Modification Recommended Service Note

N8948A - Autoranging System DC Power Supply, 500V, 60A, 10000W, 400 VAC

Serial Numbers: DE14290000 - DE15369999 without manufacturing ID Version "B"

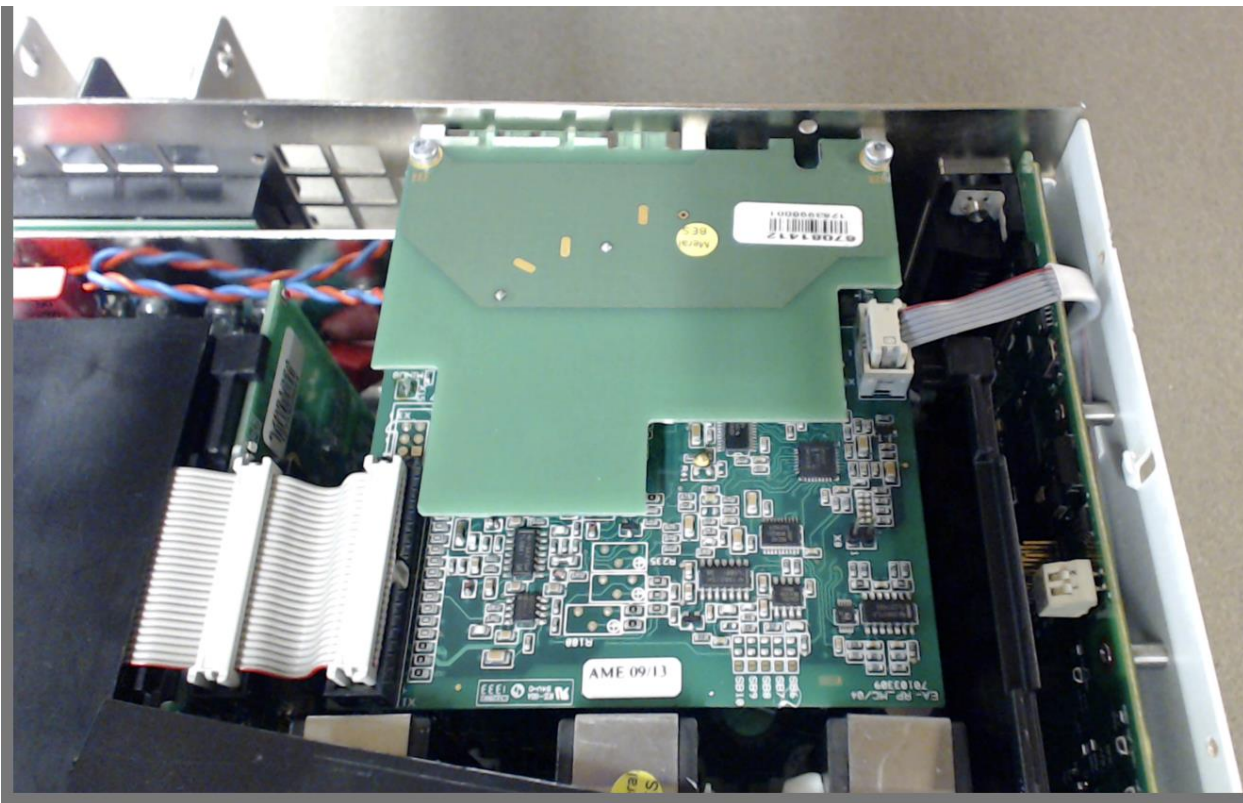
Resistors R93 and R94 must be removed, no replacement parts are required for modification.

Removal of two (2) surface mount resistors, R93 and R94, will correct this problem:

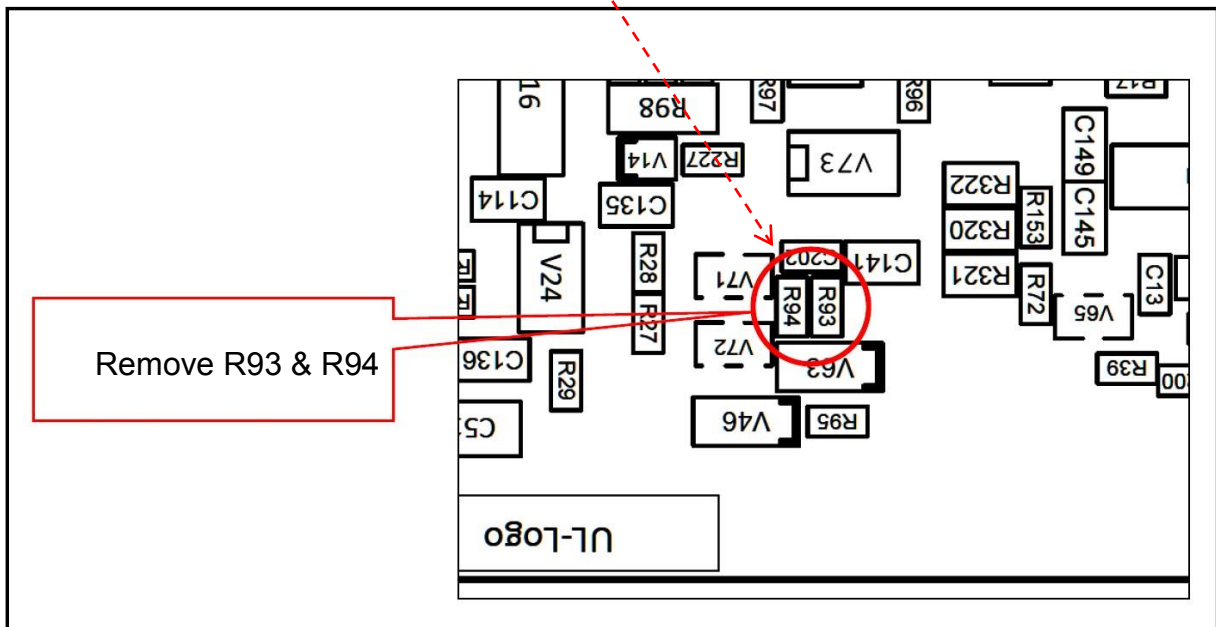
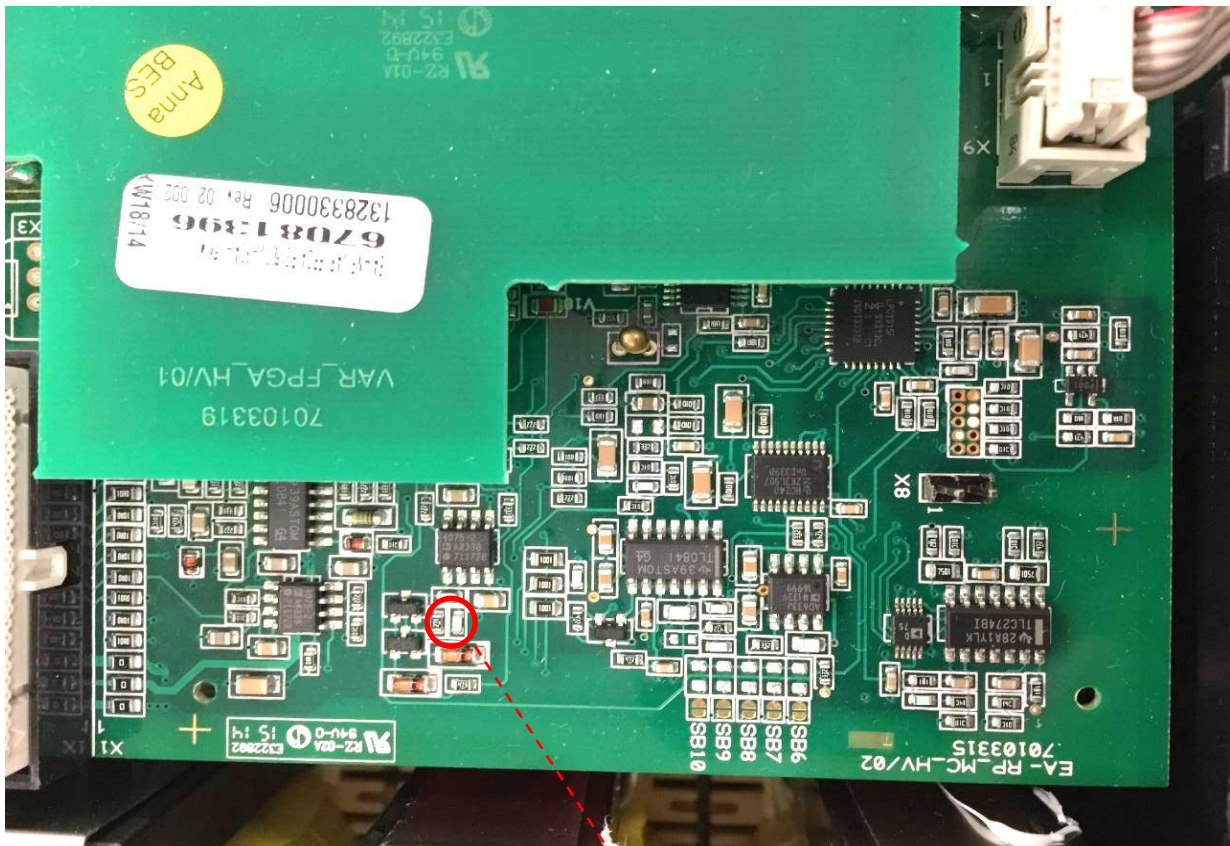
- 1) Remove acMains cable from power source.
- 2) Wait 5 minutes
- 3) Remove top cover from instrument.
- 4) In the 5kW units (viewed from the front of the unit), a small SMT assembly located at the right-rear of instrument will be readily visible (see below):

In the 10kW & 15kW units; although found in the same location, a black plastic cover will have to be removed to gain visibility and access to the SMT assembly. Plastic cover snaps-on and can be removed with a small screwdriver.

Suffix “B” added

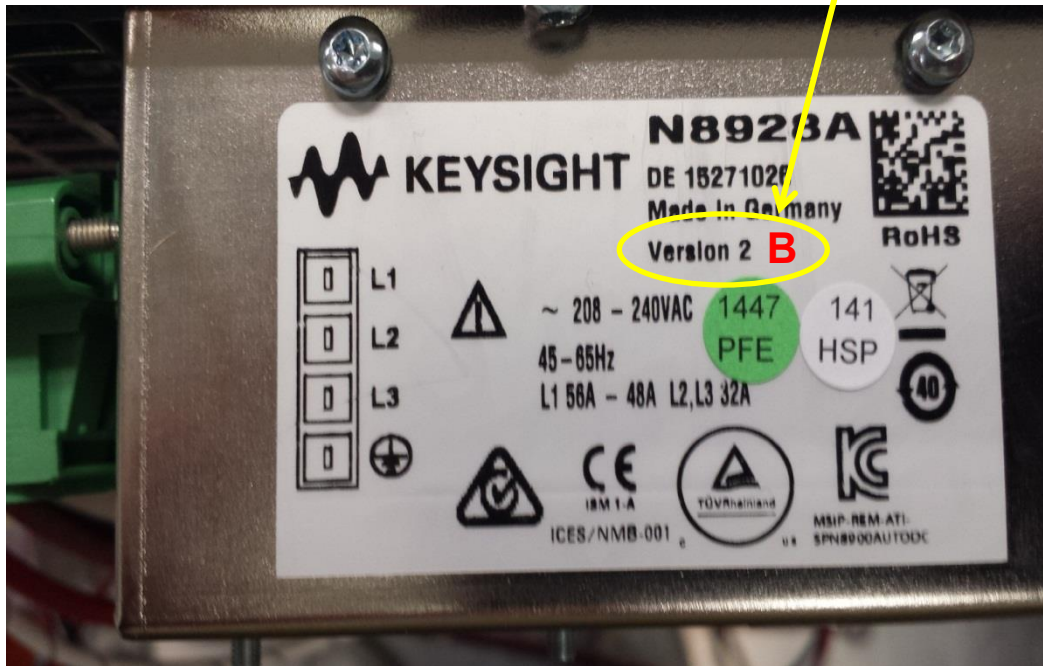
7) On the acMains label, on the rear of the instrument; use an indelible marker, to add the suffix letter “B” after the Version ID. This will assist in the tracking of modified instruments.
